SITE PLAN REVIEW

LOT NO. 12 REGISTERED PLAN 43M-2857

GREENYORK HOMES

PLAN OF SUBDIVISION OF PART OF BLOCK 203, PLAN 43M-1677 AND PART OF BLOCK 111, PLAN 43M-1712 CITY OF BRAMPTON REGIONAL MUNICIPALITY OF PEEL

LOT No. 12

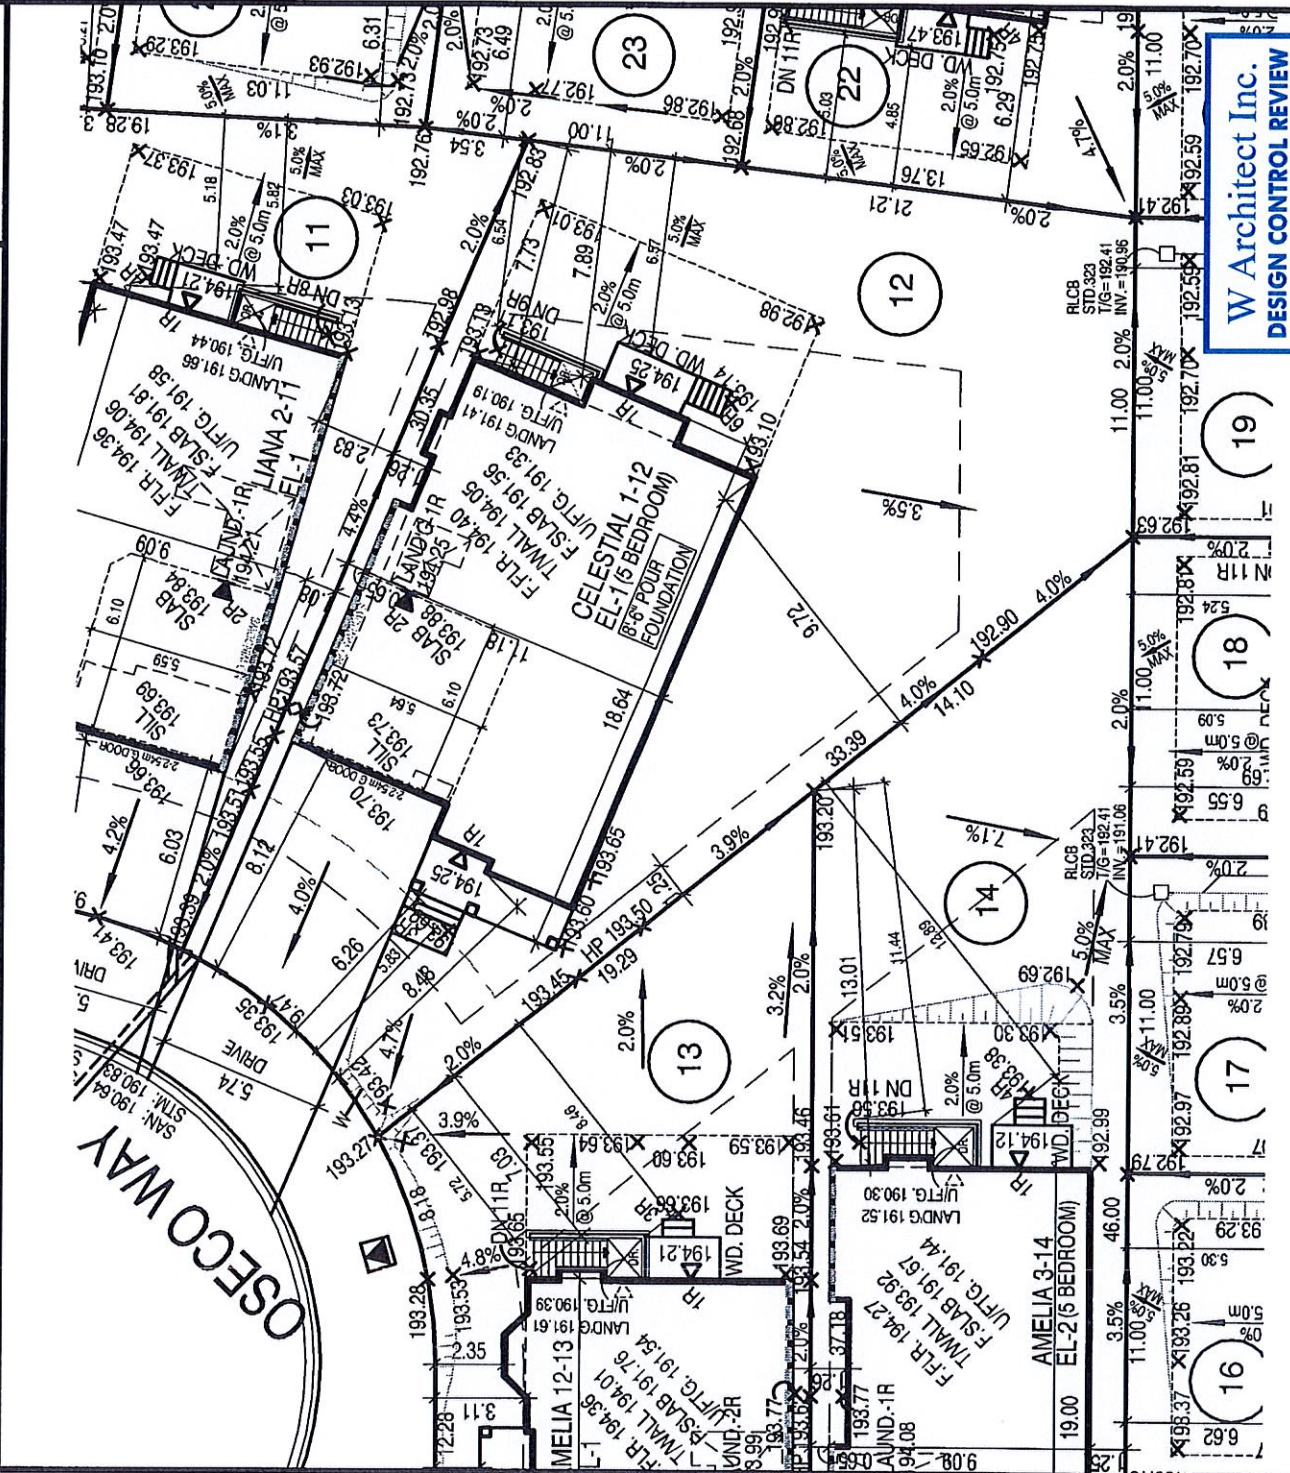
THE PROPOSED LOT GRADING AND DRAINAGE IS APPROVED AS BEING IN CONFORMITY WITH THE OVERALL APPROVED GRADING PLANS FOR THE SUBDIVISION
